P&ID
CONTAINMENT MONITORING (CM)
WM H. ZIMMER NUCLEAR POWER STATION UNIT
THE CINCINNATI GAS & ELECTRIC COMPANY
COLUMBUS & SOUTHERN OHIO ELECTRIC COMPANY
THE DAYTON POWER AND LIGHT COMPANY

DRAWING NO.
M-81 Sht. 2

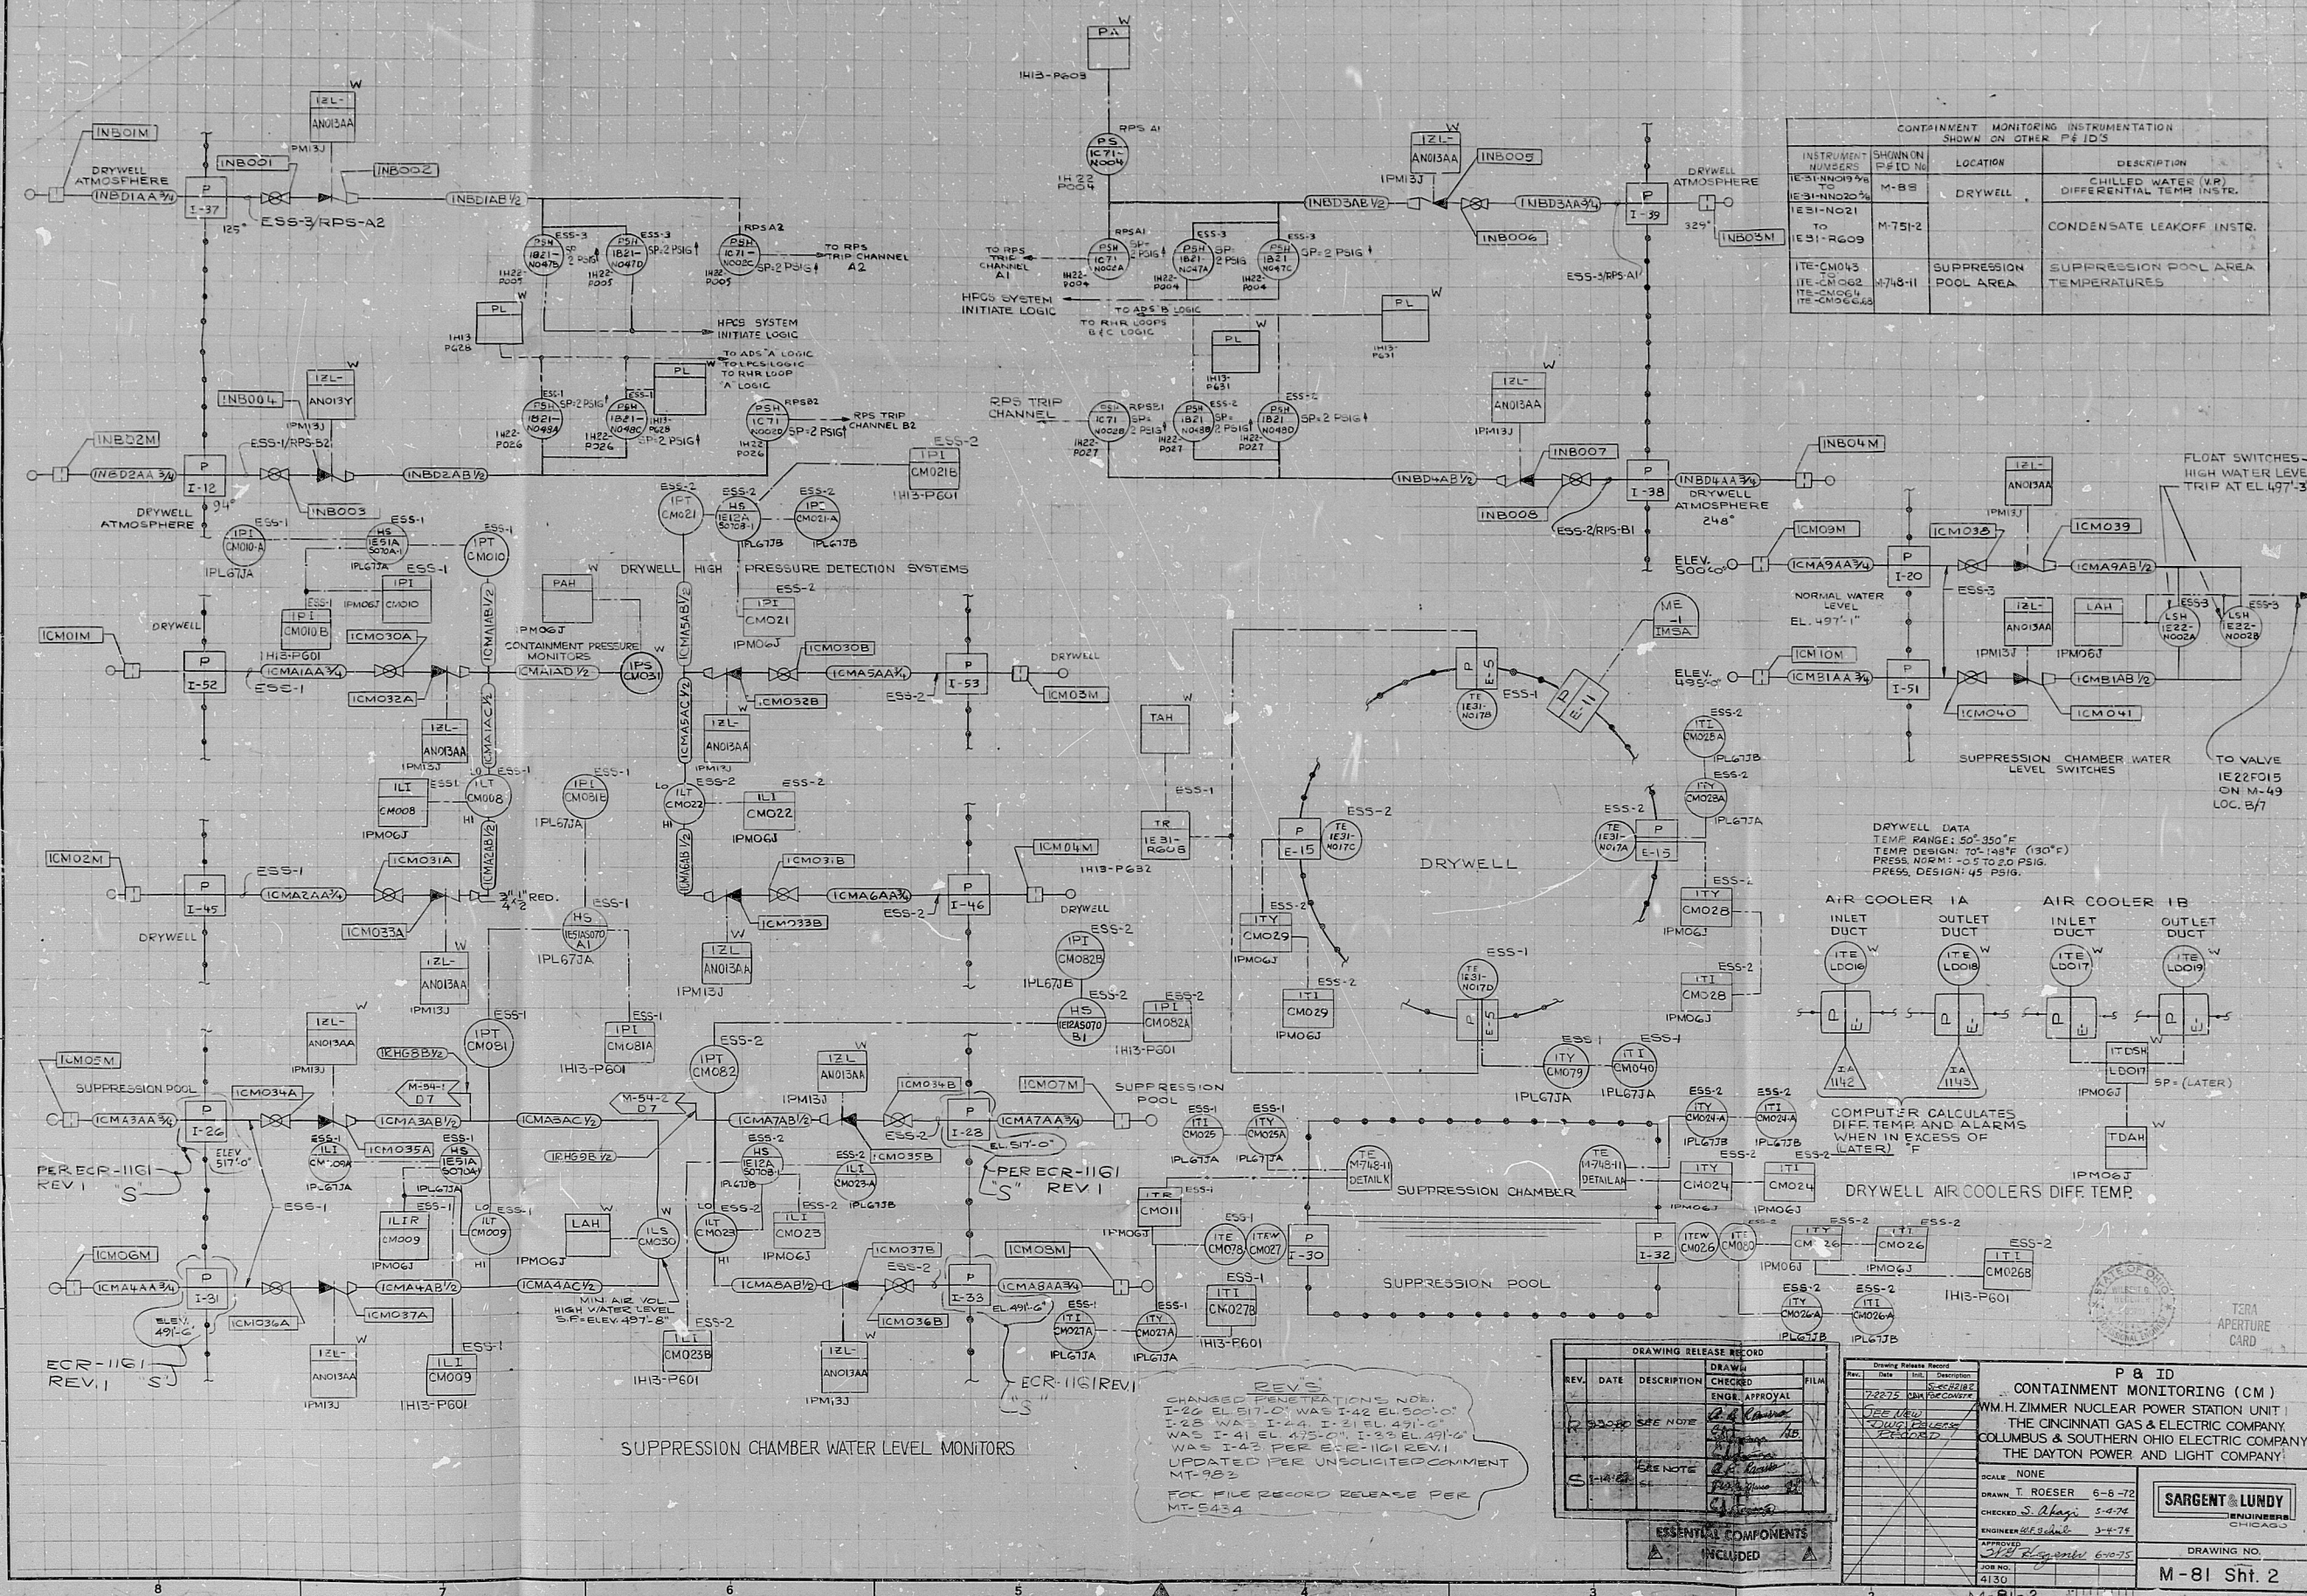
REV'S
CHANGED PENETRATIONS NO. 1
I-25 EL. 517'-0" WAS I-42 EL. 500'-0"
I-25 WAS I-44 I-21 EL. 471'-0"
WAS I-41 EL. 475'-0" I-23 EL. 471'-0"
WAS I-43 PER ECR-11G1 REV. 1
UPDATED PER UNSOLICITED COMMENT
MT-982
FOR FILE RECORD RELEASE PER
MT-5434
